PLANNING COMMISSION MEETING

LOCATION: TOWNSHIP ANNEX, 7527 HIGHLAND ROAD, WHITE LAKE, MI 48383
THURSDAY, JULY 20, 2023 – 7:00 PM

RE: Sunset Cove Condominiums- Preliminary Site Plan Review – 3rd Review

RE: Sunset Cove
Preliminary Site Plan and Special Land Use – Review #3

A200

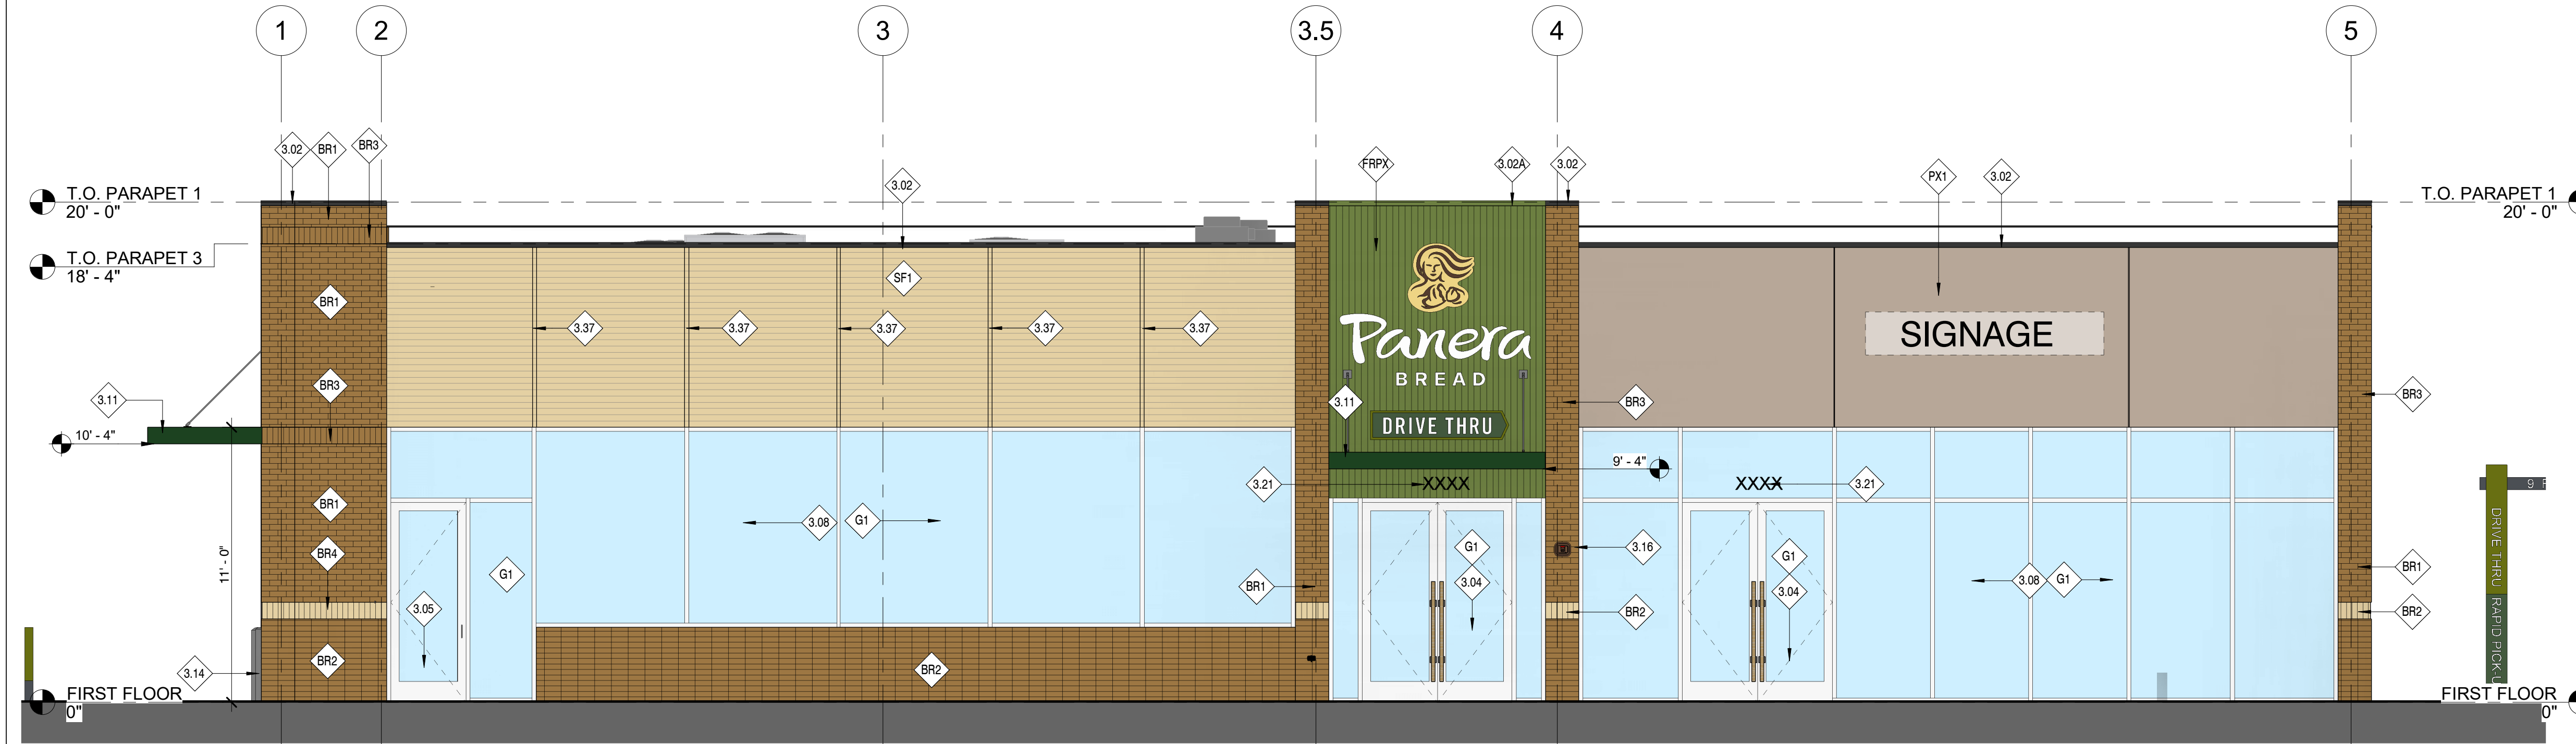
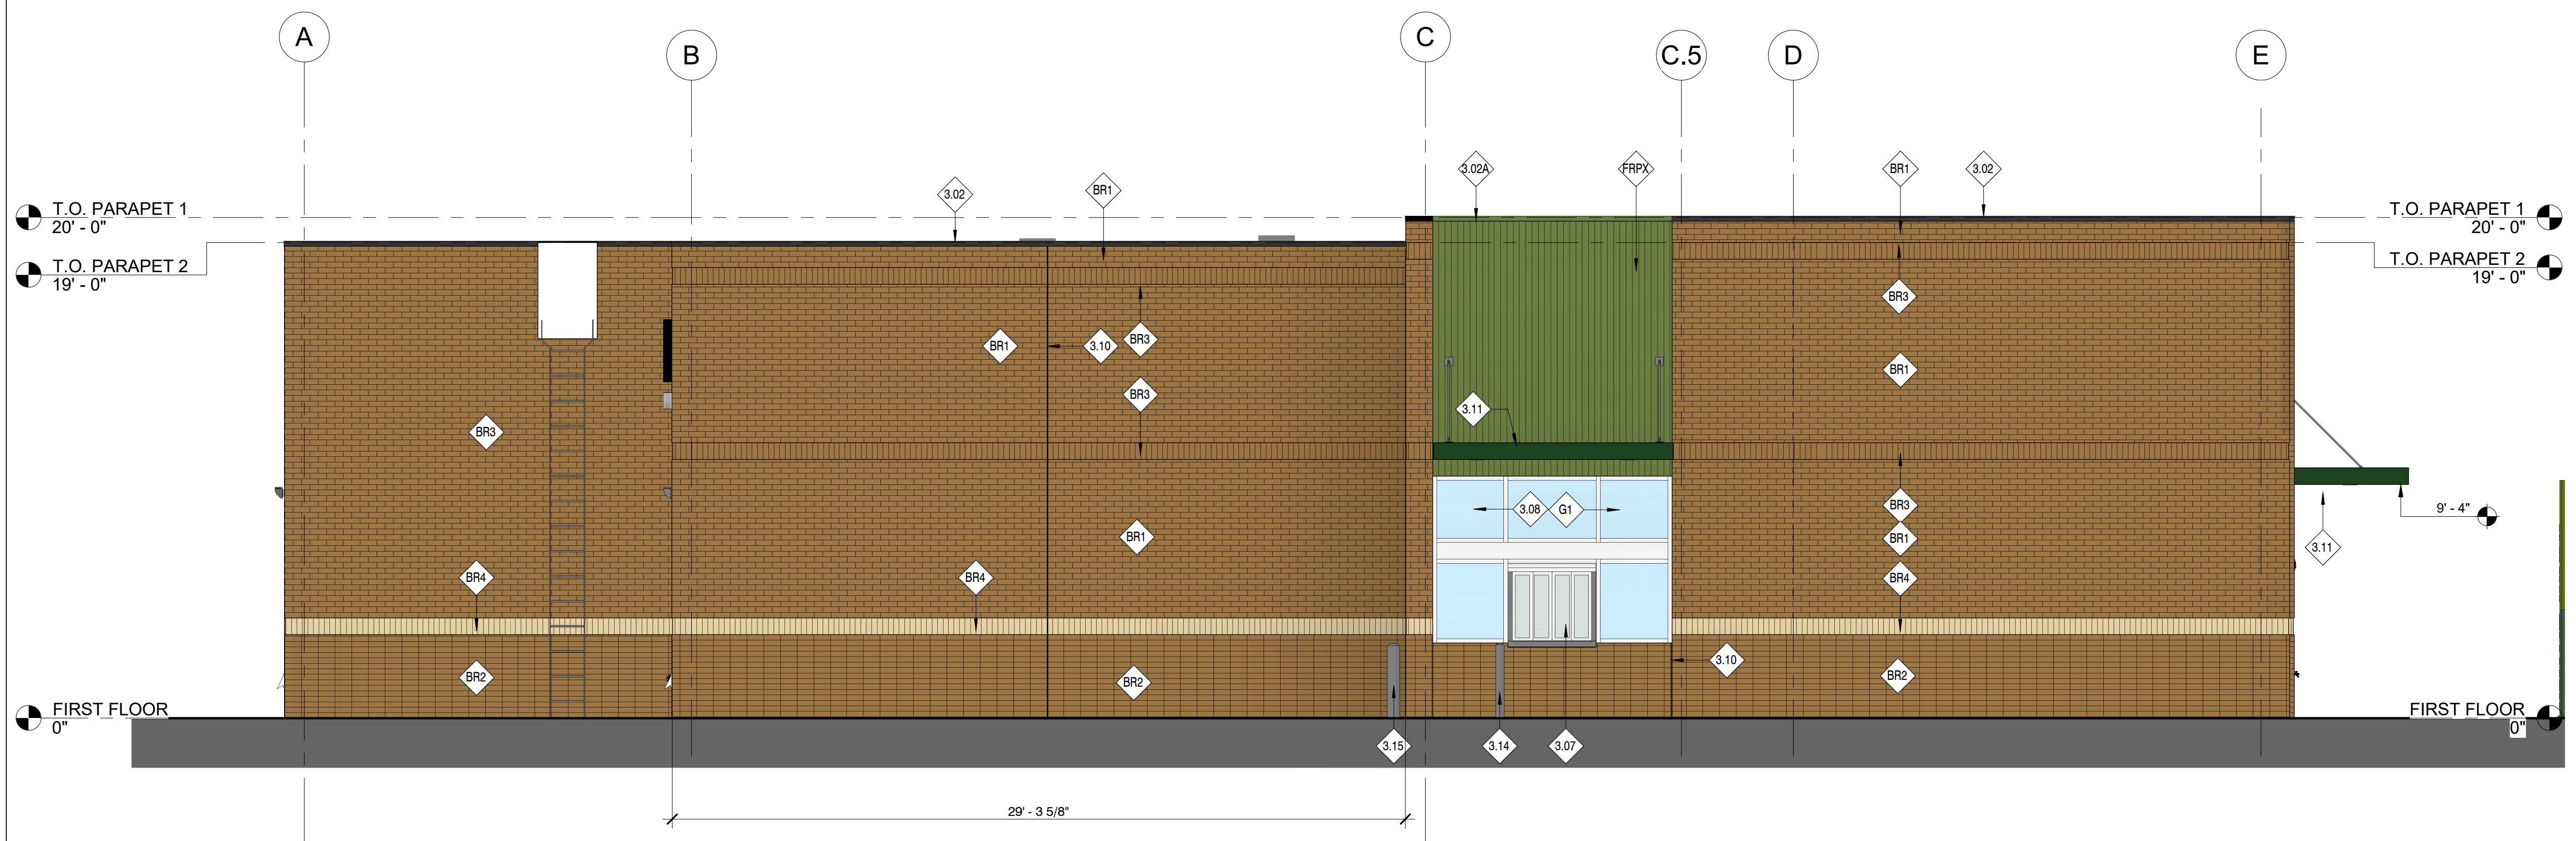
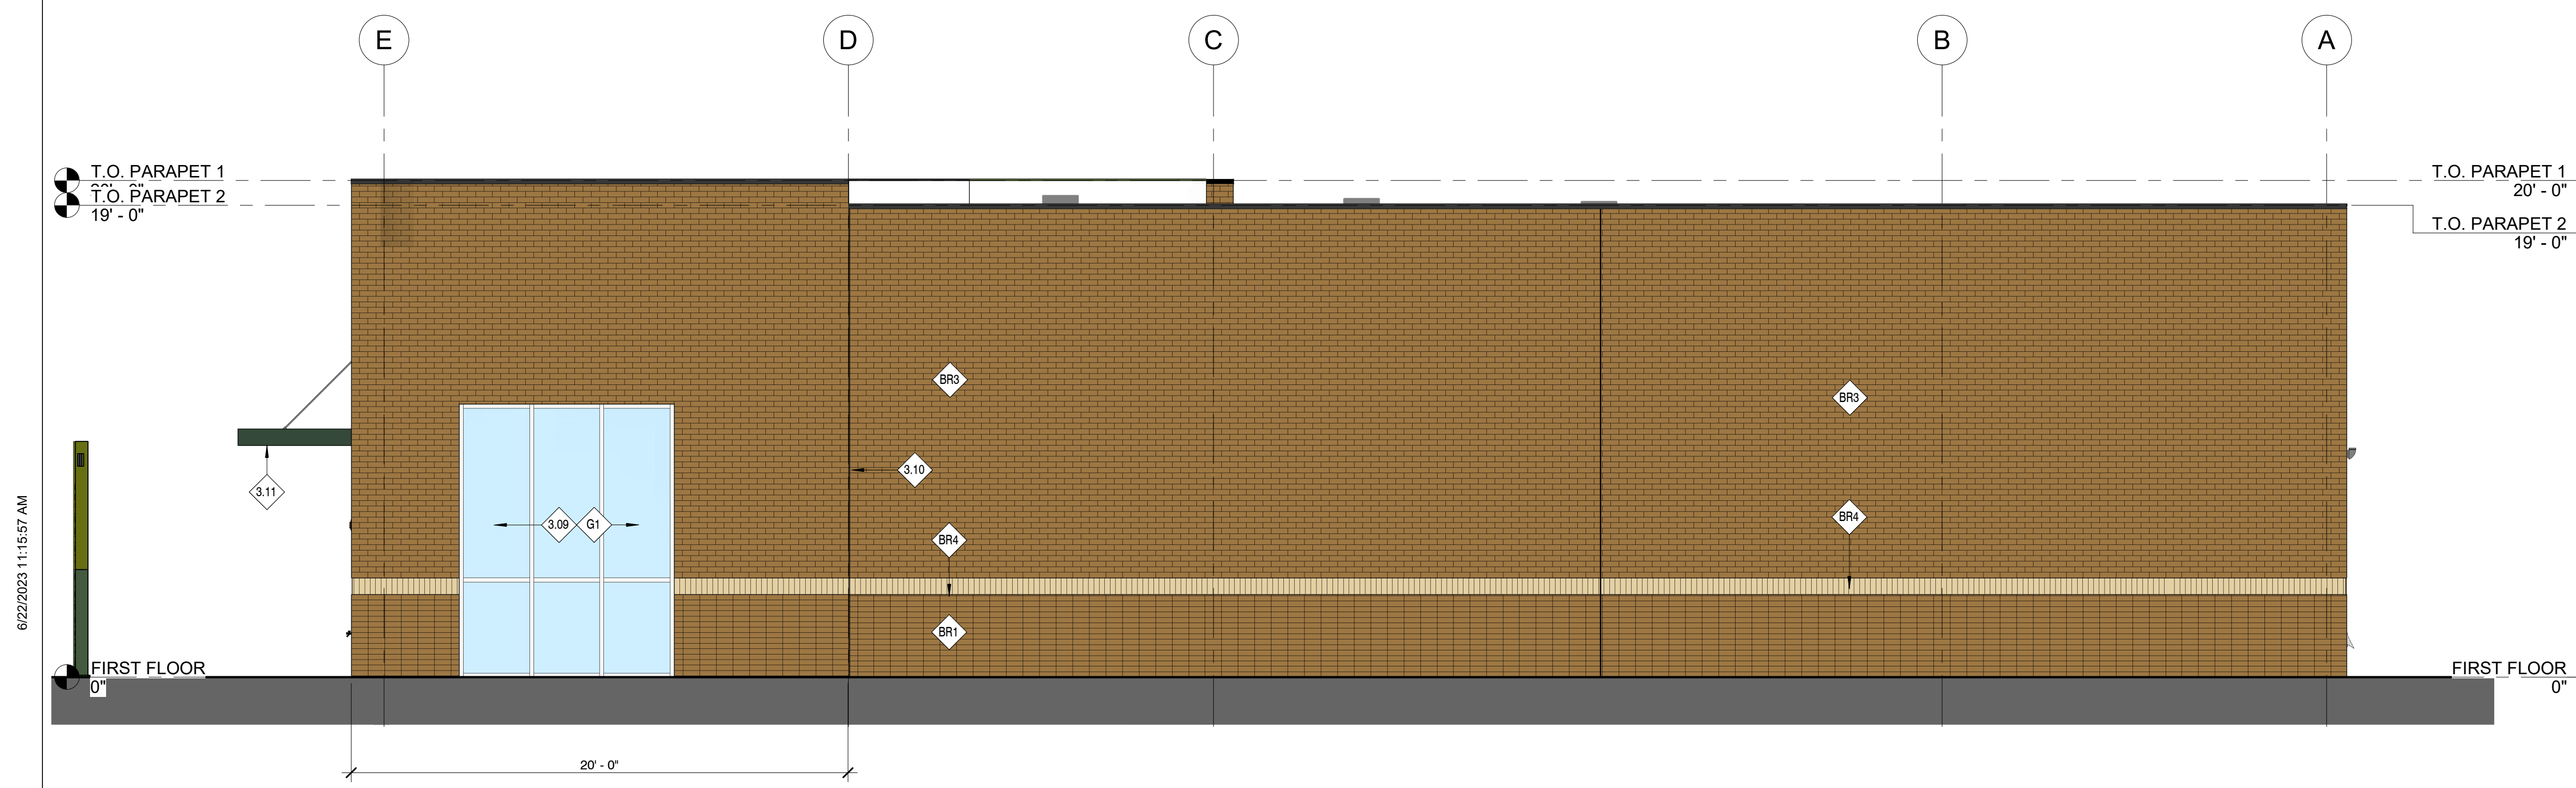
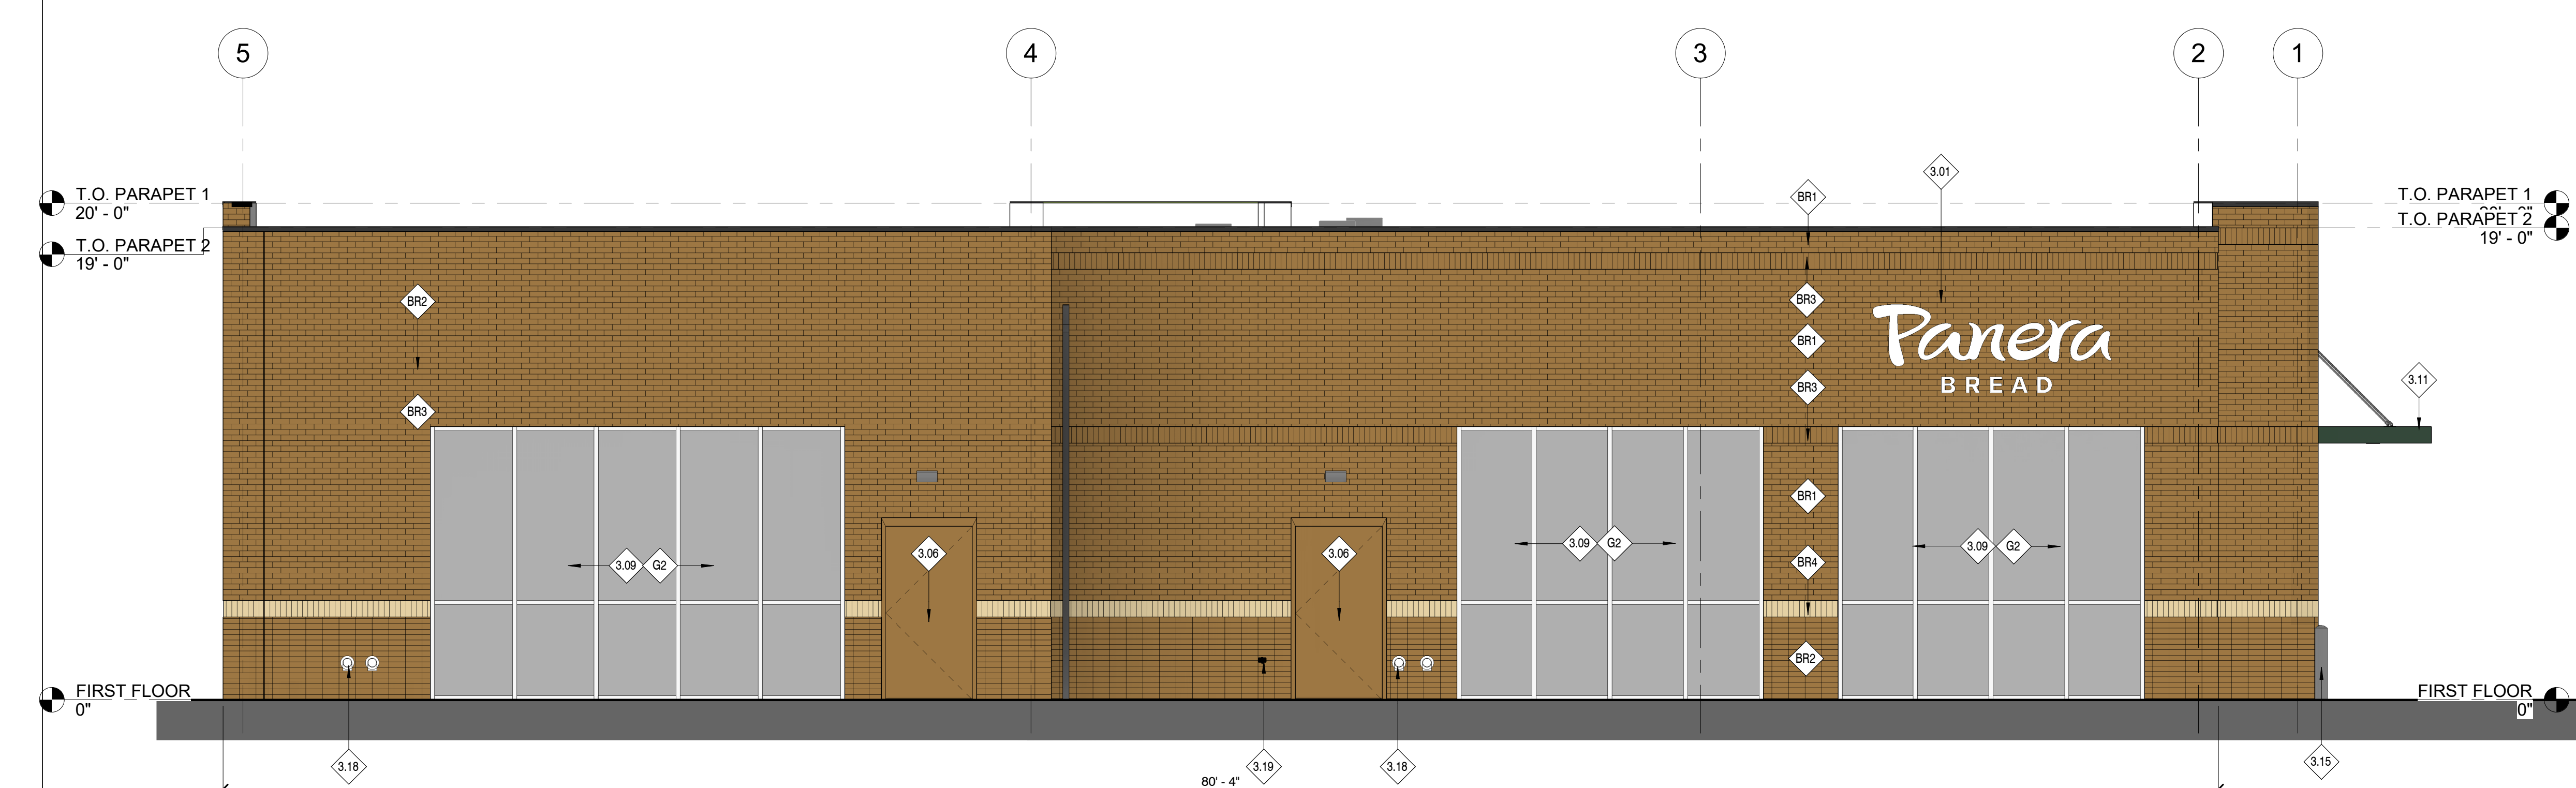
- The building material percentages on Sheets A.200 and A.201 do not result in 100 percent. Furthermore, on Sheets A.200 and A.201 the facade areas next to the elevations differ from the sum of the material areas listed in the tables on those sheets. Revise for consistency.
